Mtg Date: February 28, 2019
To: Planning Commission
From: Julie Johnston, AICP
Subject: AMENDED Advia Credit Union Site Plan

New Headquarters Facility for:
Advia Credit Union
6400 WEST MAIN ST. · KALAMAZOO, MI 49009

2 LIGHT FIXTURE POLE INSTALLATION DETAIL
SCALE: NONE

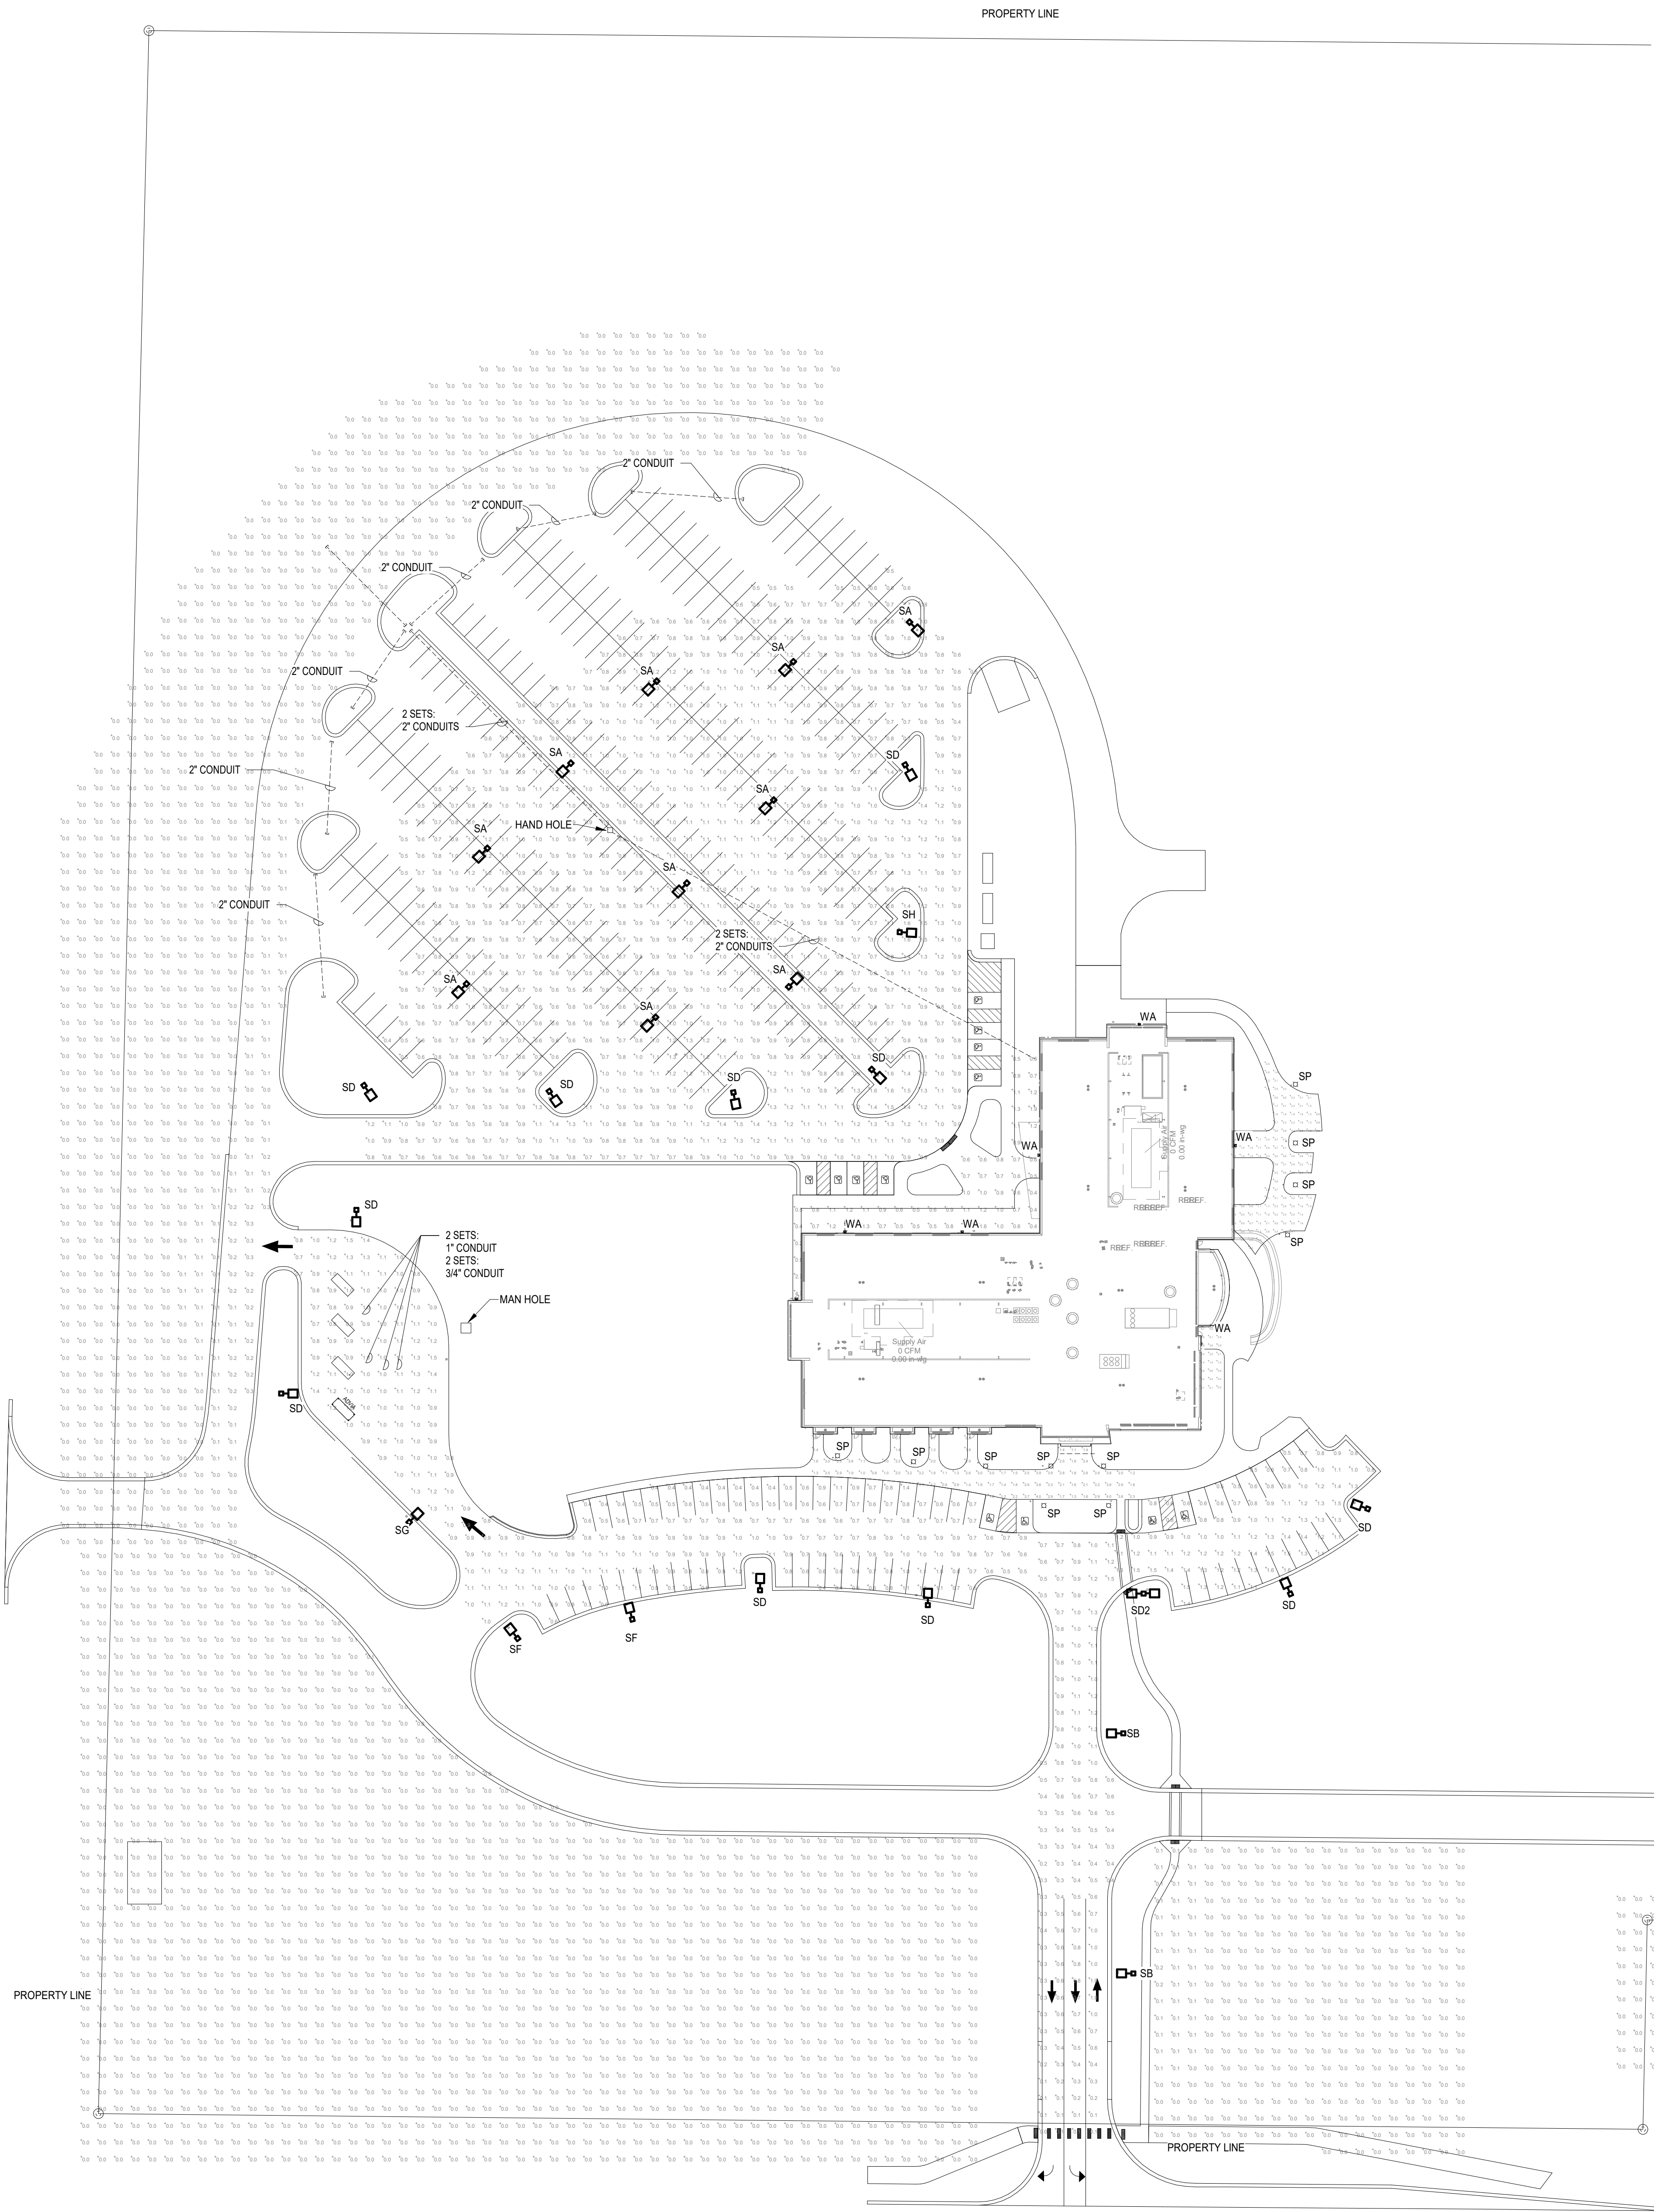
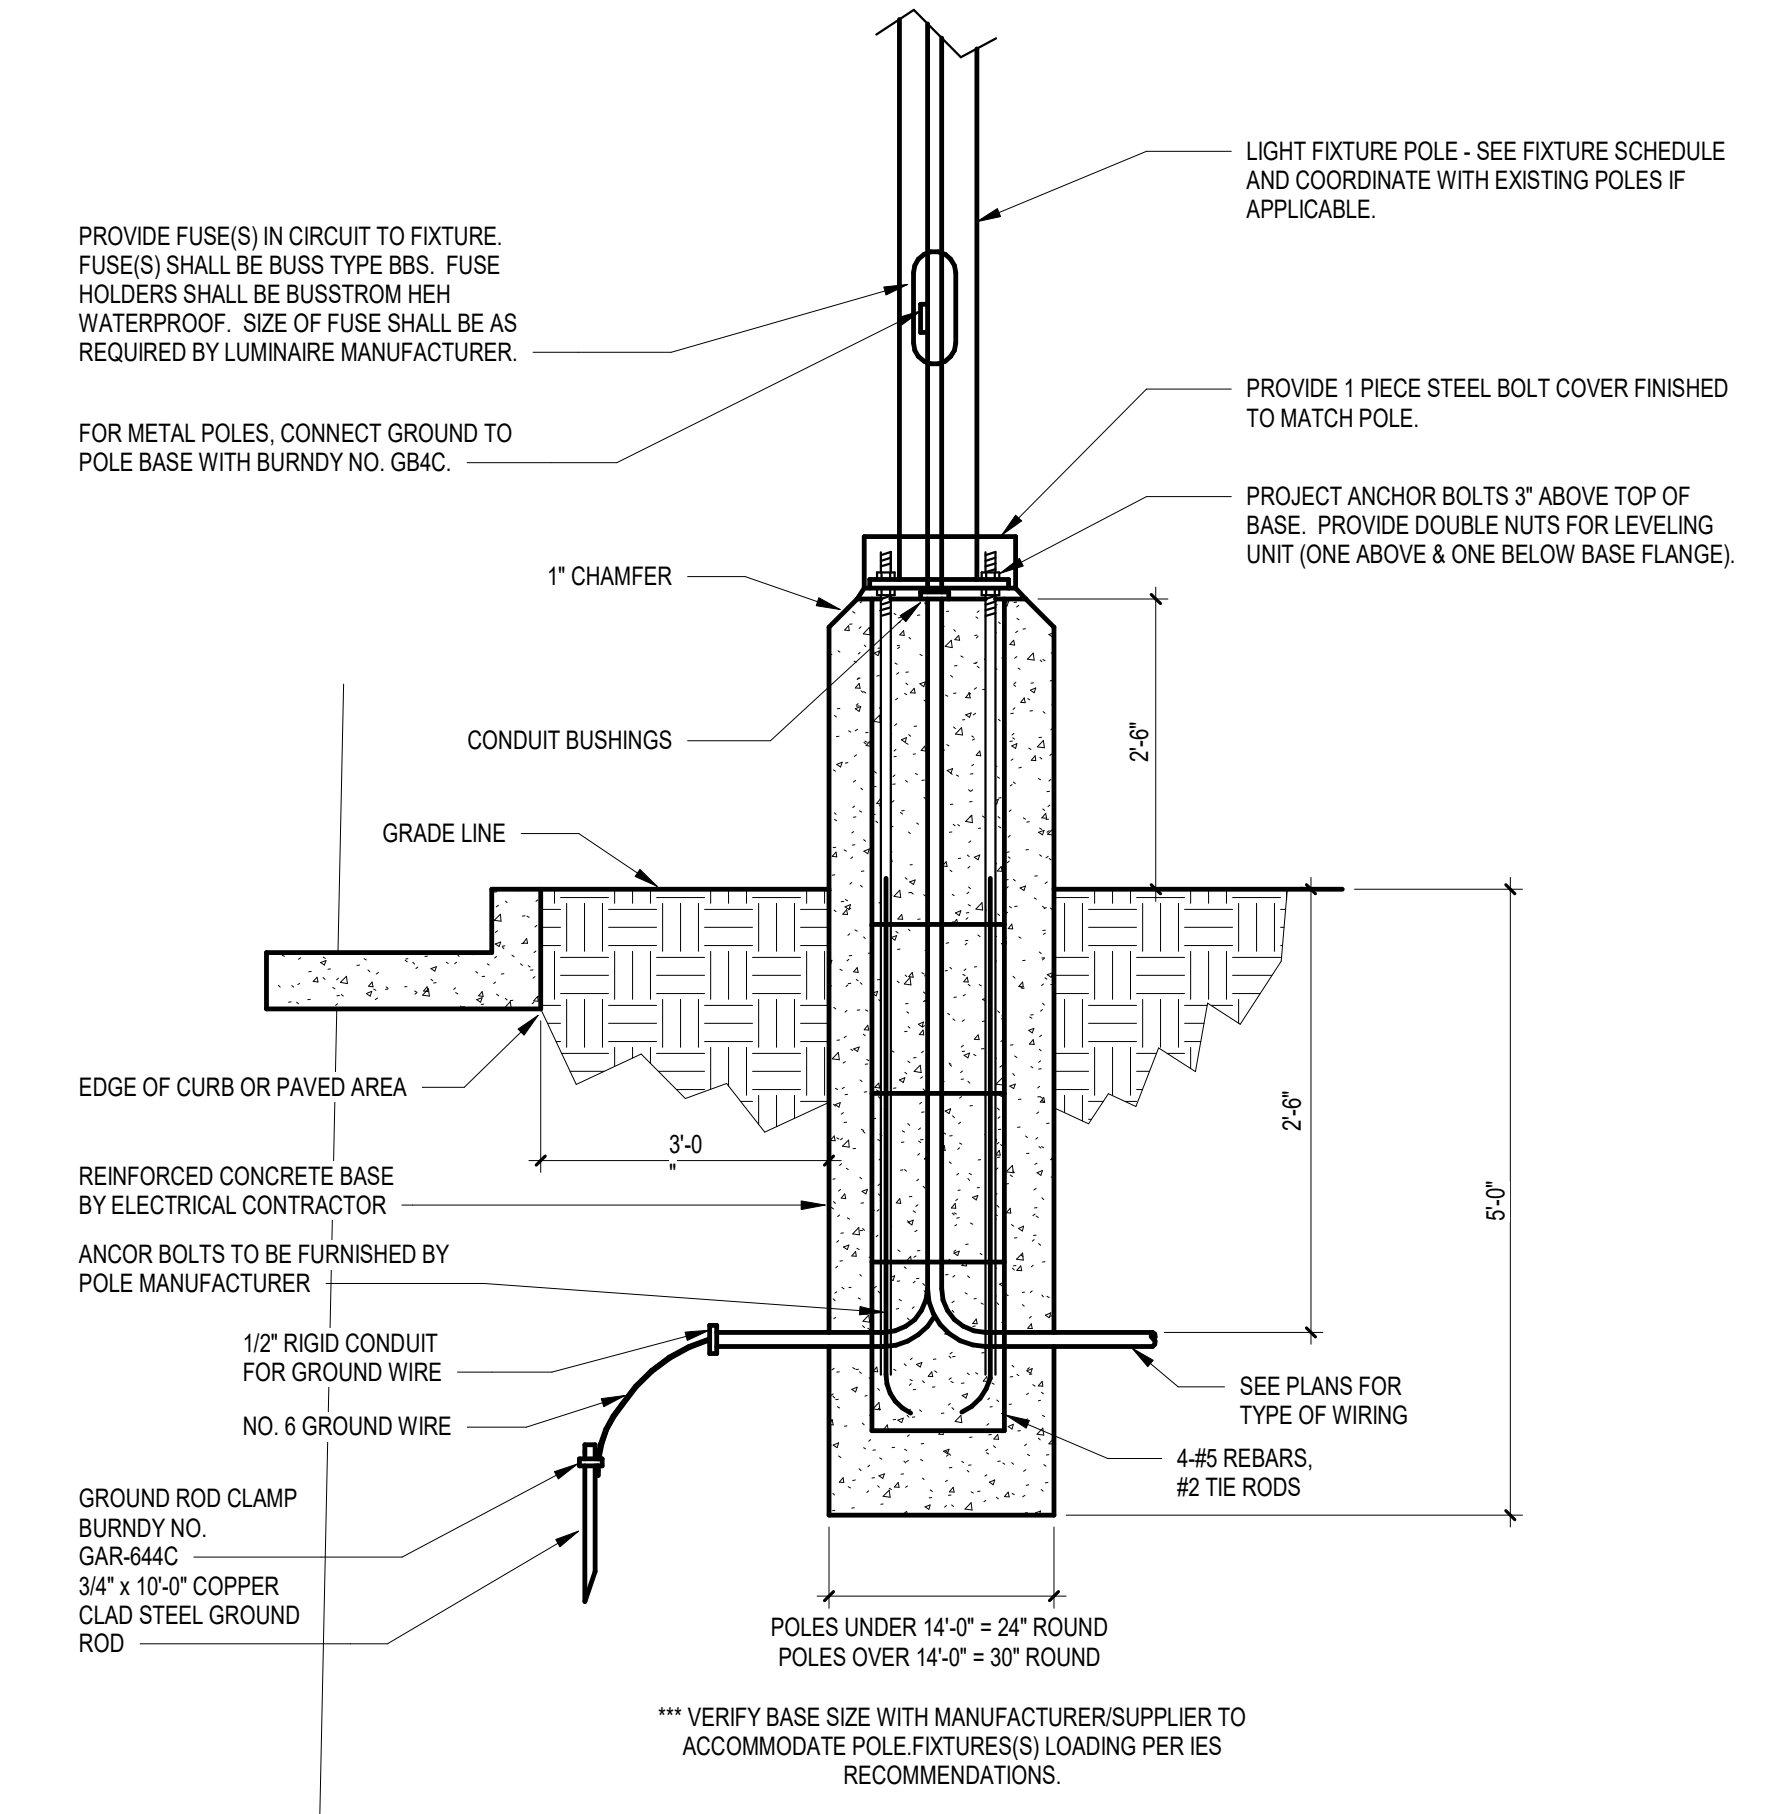
- **The lighting specifications for the building and architectural pole lighting needs to be provided to the Township. In addition, a note should be placed on the photometric plan that all lighting will be full cut-off and downward directed. Finally, information needs to be included on the photometric plan related to reduced lighting during non-business hours.**

Staff believes the first note should have read “*shall be reduced to 30% power within one hour of the end of business operation or midnight, whichever is later...*” The Planning Commission will need to determine if the percentage and timing for reduced lighting is appropriate. The Lighting Ordinance states the following:

The lighting specifications (cut-sheet details) for the building and architectural pole lighting is still needed.

The Planning Commission may wish to consider changing the note on the lighting plan regarding the reduction in lighting during nonbusiness hours to be changed to:

14. All exterior light fixtures shall be reduced to 30 percent power at one hour after the end of business operations or 10:00 pm, whichever is later, until 7:00 am or business opening, whichever is earlier via an owner programmable timer through the lighting control panel.

The applicant has placed notes on the lighting plan that indicate the following:

- All exterior light fixtures shall be reduced to 30% power from midnight to within one hour of the end of business operations, whichever is later, until 6 am or business openings, whichever is earlier (owner programmable time) vial timer function through the lighting control panel.
- All light fixtures shall be full cut-off and orientated downward.

7-27-2018 Site Plan Submitted
 8-6-2018 Site Plan Submitted
 1-15-2019 Site Plan Submitted
 12-10-2018 Site Plan Submitted
LANDSCAPE PLAN

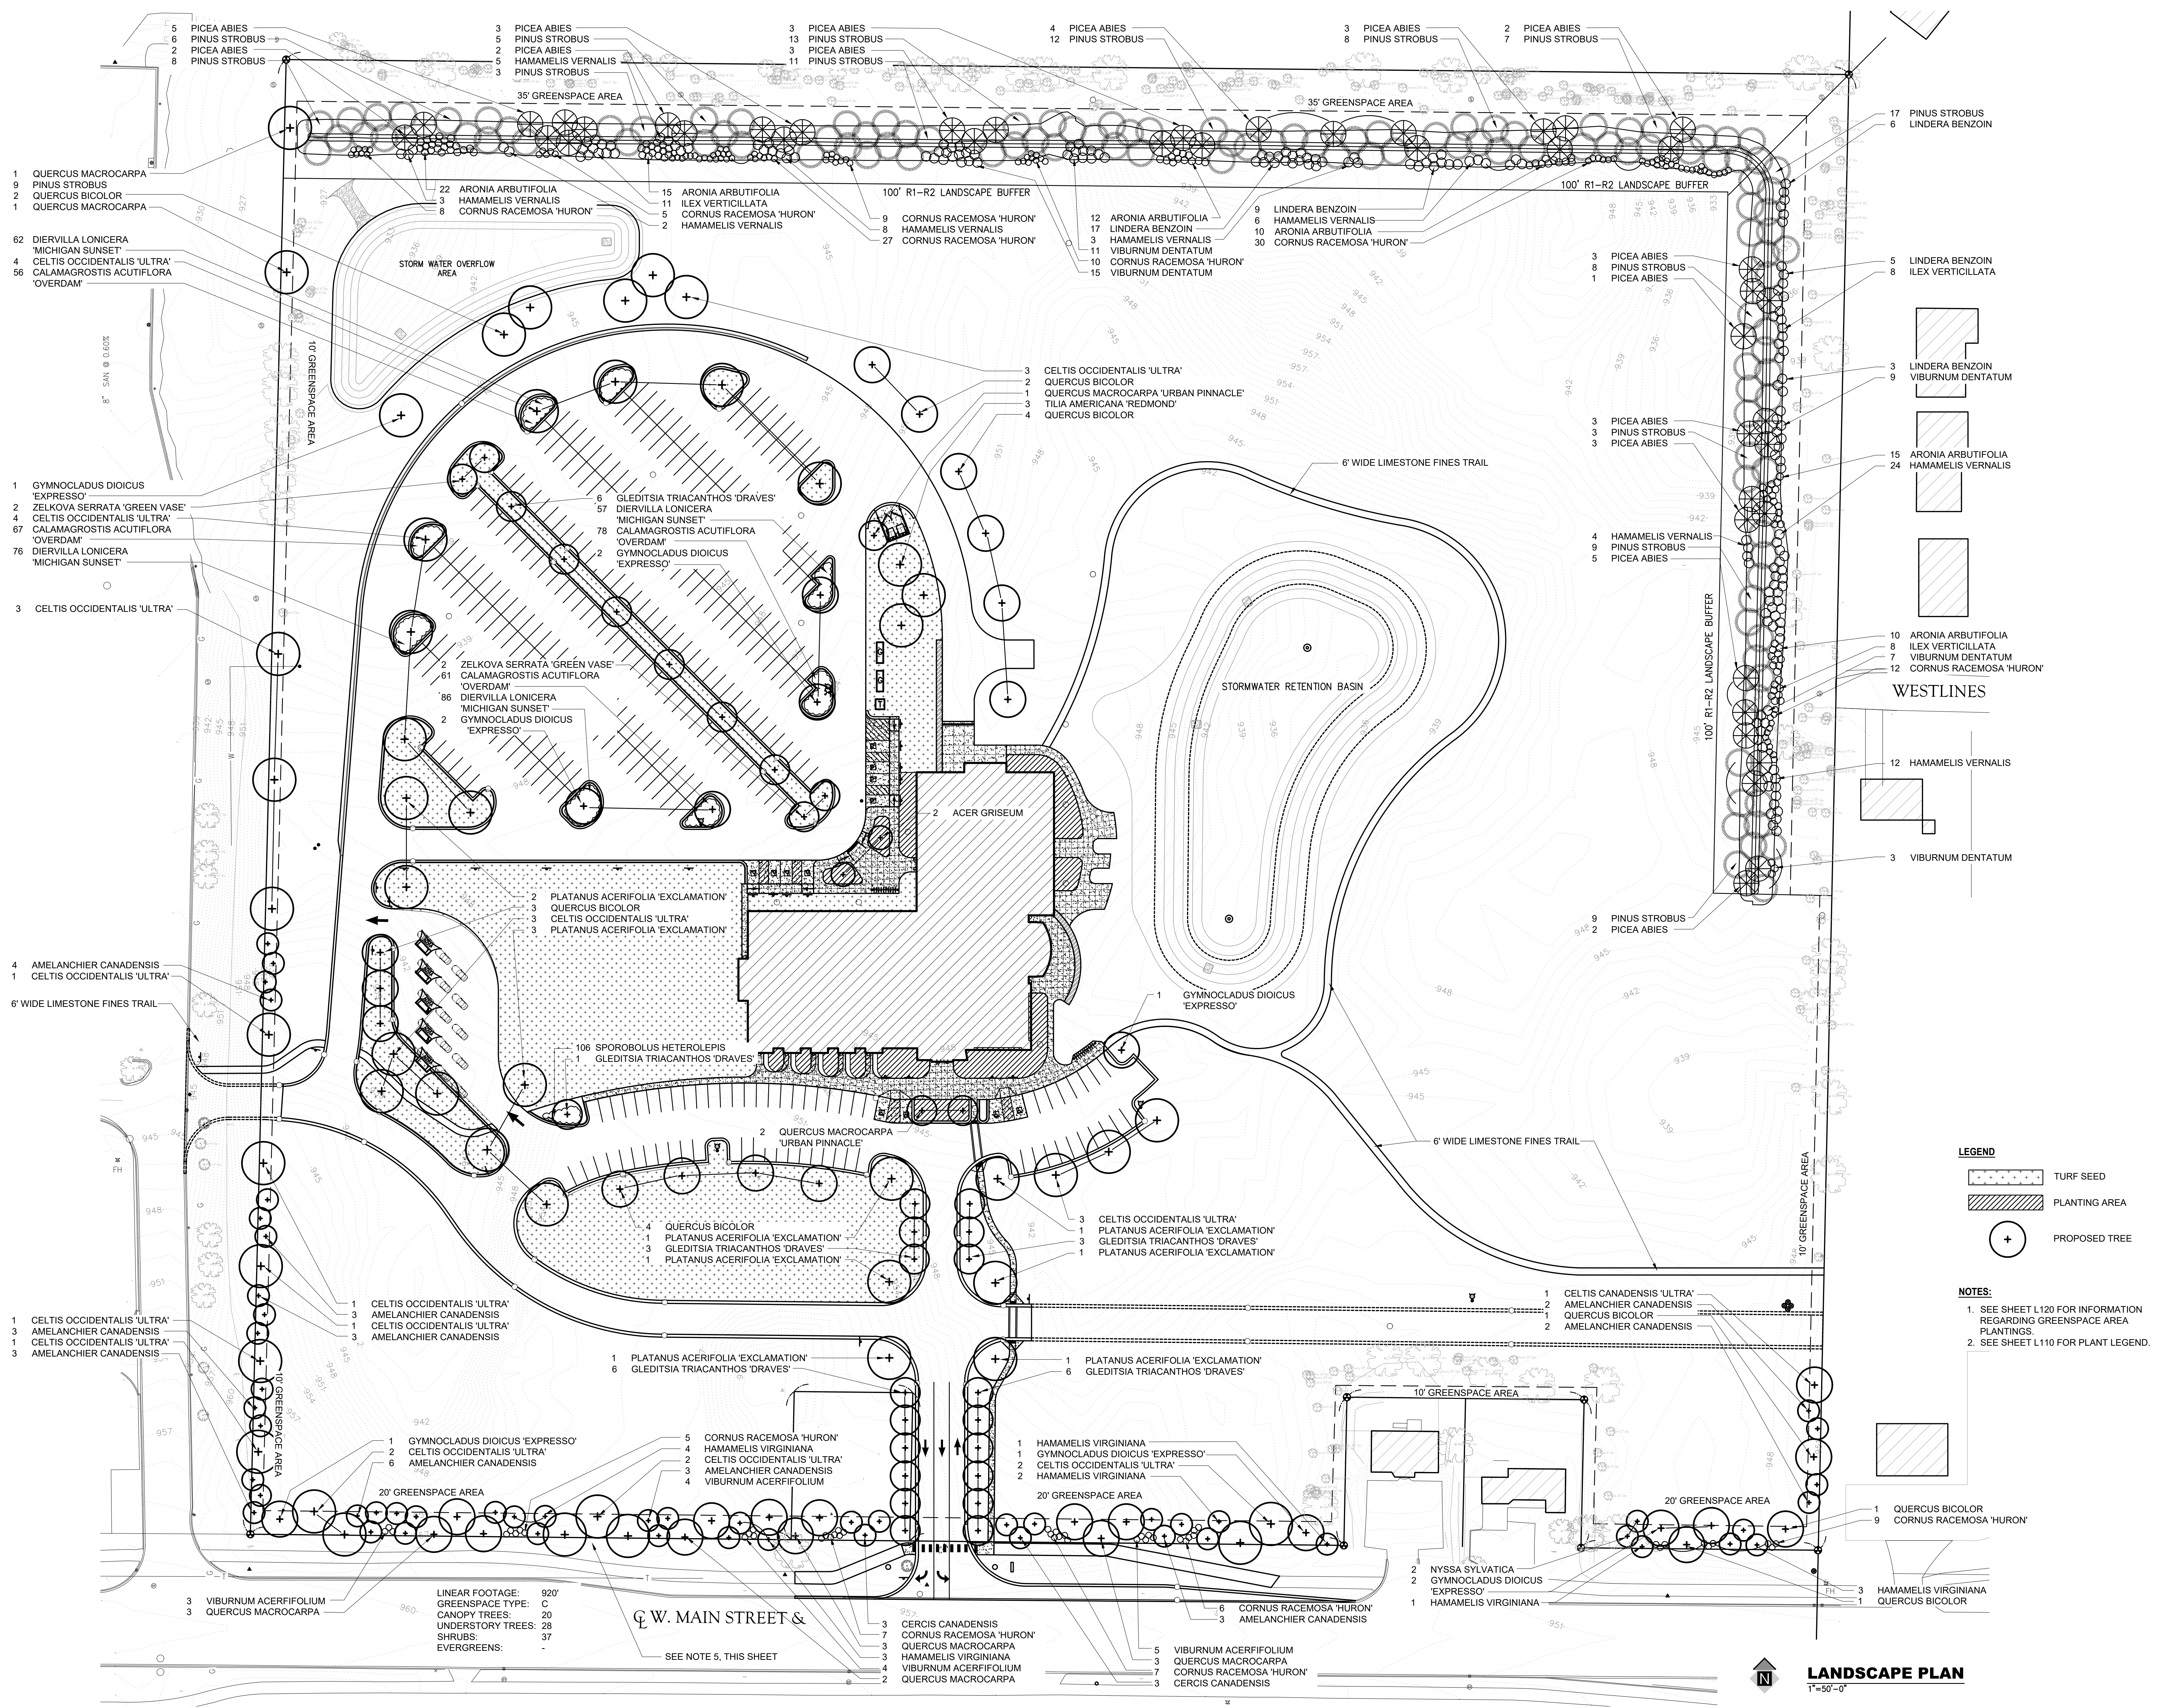
- **The evergreen trees required by Section 75.130 must be installed within the 100-foot buffer area.**

This requirement has been met. It should be noted that the landscape materials are planned to be placed on the proposed buffer. Staff is concerned about long term viability of the plants and wants to ensure the applicant understands as a requirement of the Ordinance, the trees will have to be replaced if they do not survive, as follows:
